February 28th 2014: PRODUCT STATUS NOTIFICATION – MinVee® Track Mounting Spacer MV0S18H

Bishop-Wisecarver Group is informing you of the obsolescence of components from the MinVee® miniature linear guide product line.

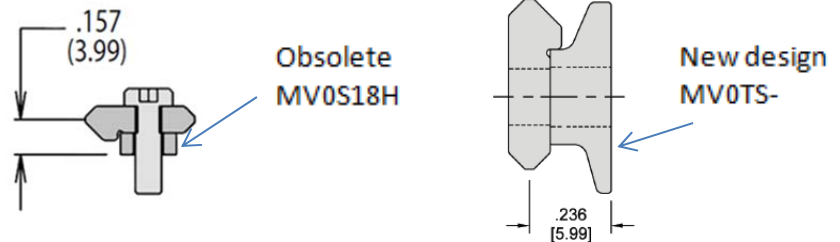
The track spacer is an optional small washer type standoff used for mounting the MinVee® track. These track spacers are sold in quantities of “each” and the required quantity should match the number of holes on the track.

See image.

The MV0S18H track mounting spacer has been discontinued and replaced by an improved track mounting method via a support extrusion made from 6061-T6 aluminum. This new MinVee® track mounting method provides continuous support to the track along the entire length and is available for all standard catalog track lengths. When ordering, the quantity is 1 each per length of track.

The new track support has slightly taller mounting height (0.079” taller).

To support your application needs, please use the following codes when ordering track supports:
